91-~~14~~⁴⁵ SUMMIT STREET

AP-105 Summit Street

In accordance with the telephone conversation with you, we are issuing a permit to construct a one story frame addition in accordance with the following conditions:

WORK	Durost	
CLASS	Alas. Parting Surges	
DRAWING	Section	
SCALE	PROPERTY OF	REVISIONS AND NO.
$\frac{1}{8}'' = 1' - 0''$	H. T. FOX CO., INC.	
DATE	PORTLAND, MAINE	5
10/21/54

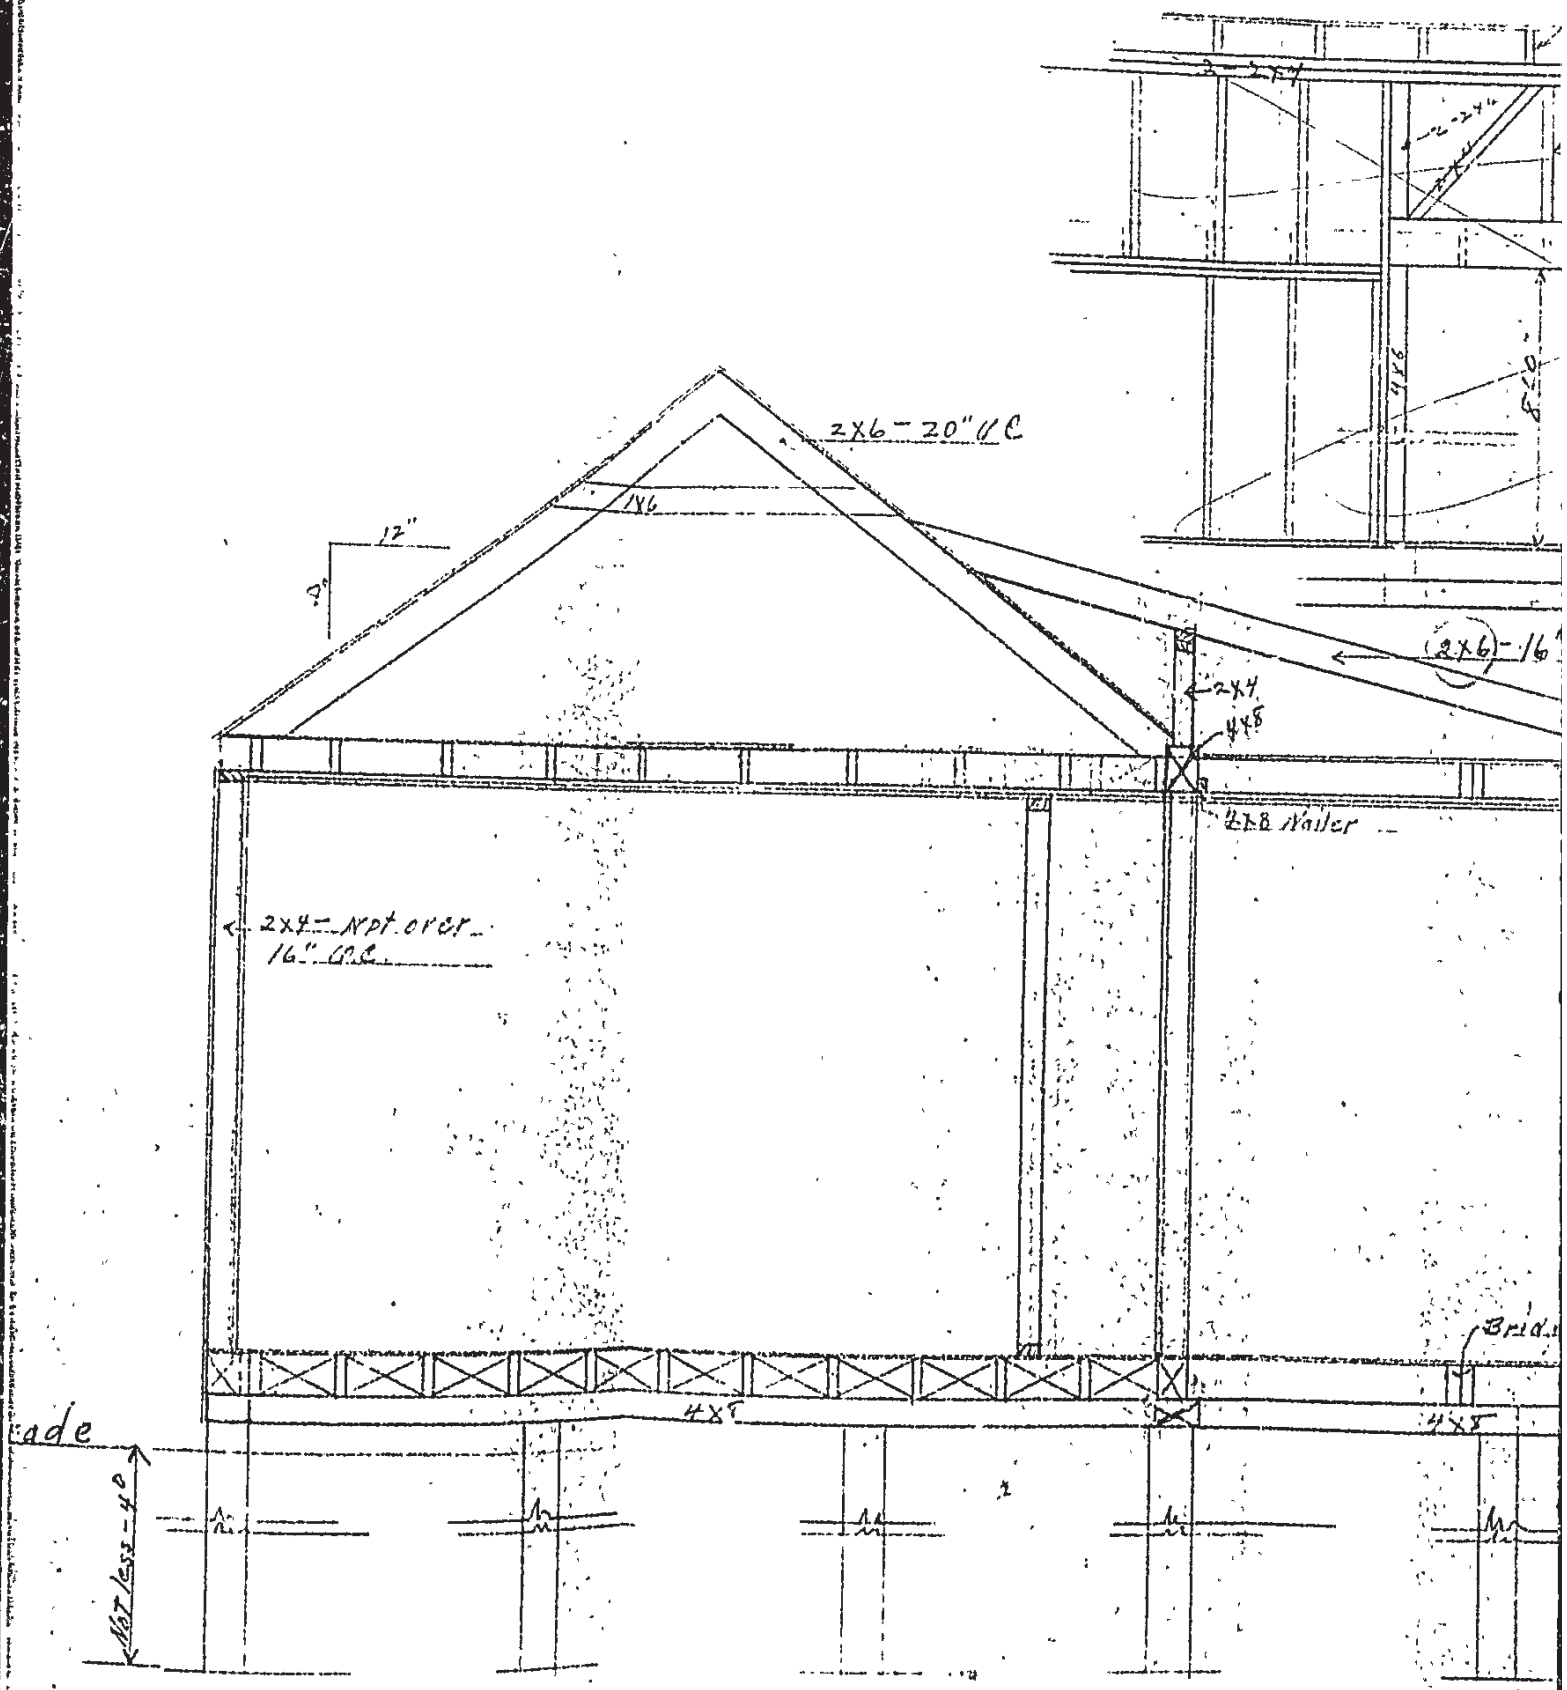
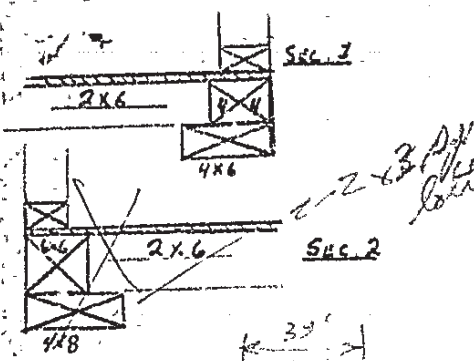
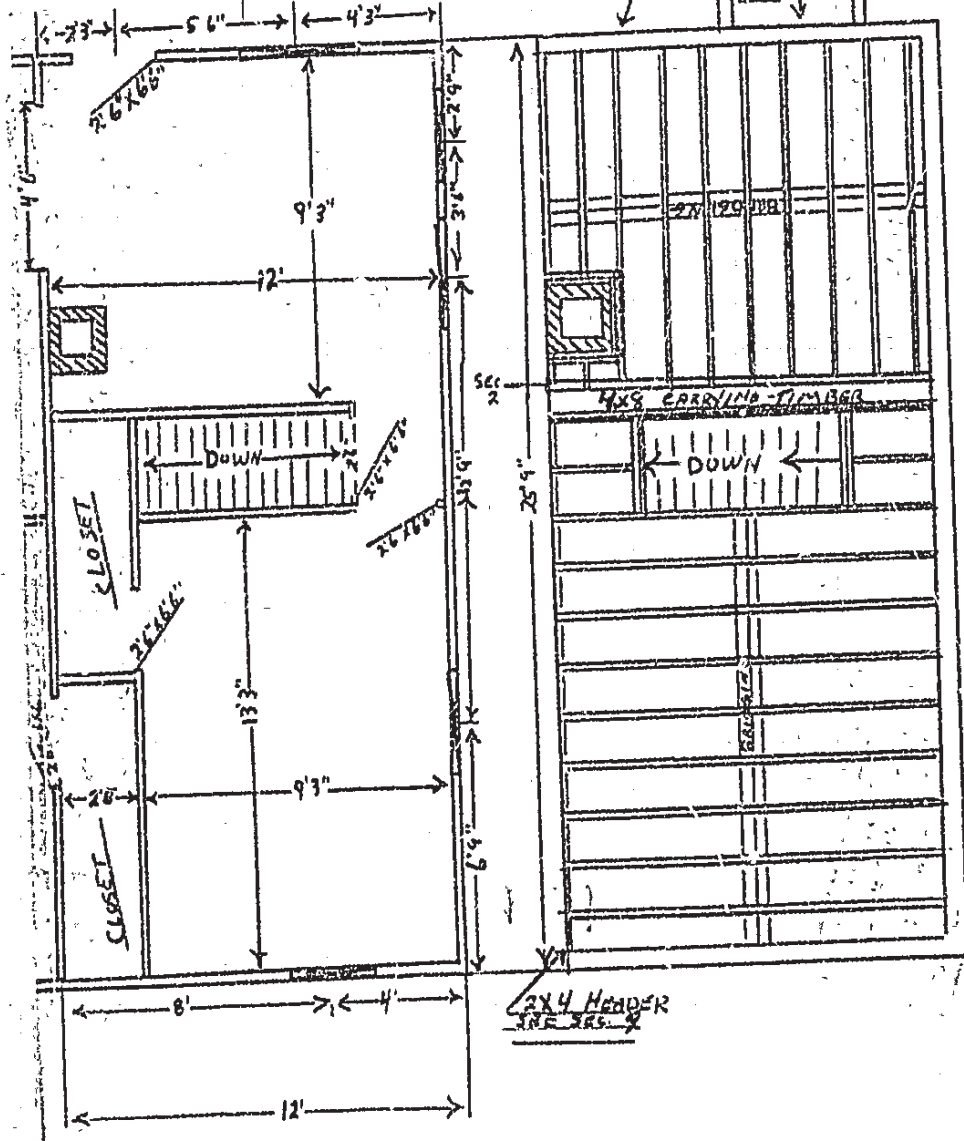
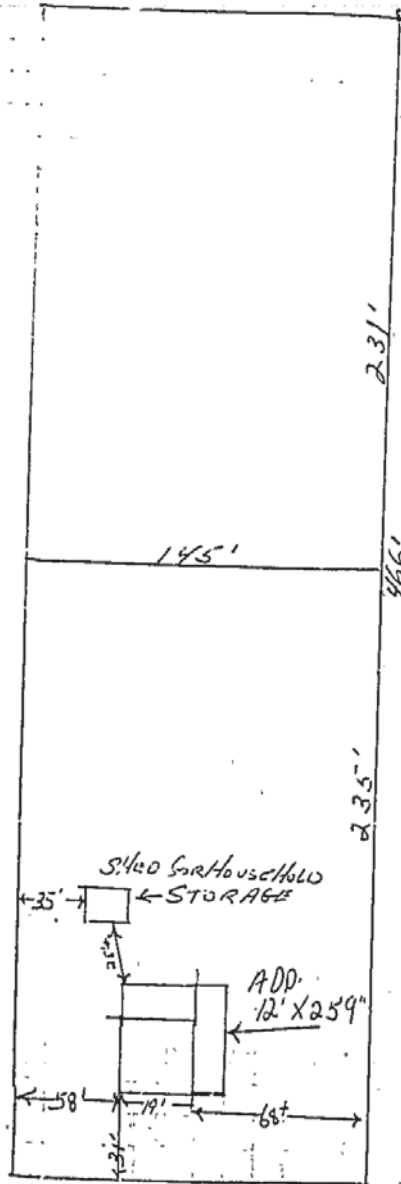
1. In accordance with the Code, the footing under the 12 inch block wall shall be a minimum size of 8 inches deep and 15 inches wide.
- ✓ 2. The carrying timber supporting a floor load and partition load at stairwell will need to be 4 inches by 10 inches.
- ✓ 3. If the floor timbers do not bear directly on the sill as shown in the sections then the joists shall be supported on a wooden strip no less than 2 inches by three 3 inches, nominal dimension, spiked or bolted to the wood sill.
- ✓ 4. Two by eight inch rafters will be required for a roof of this pitch and span.
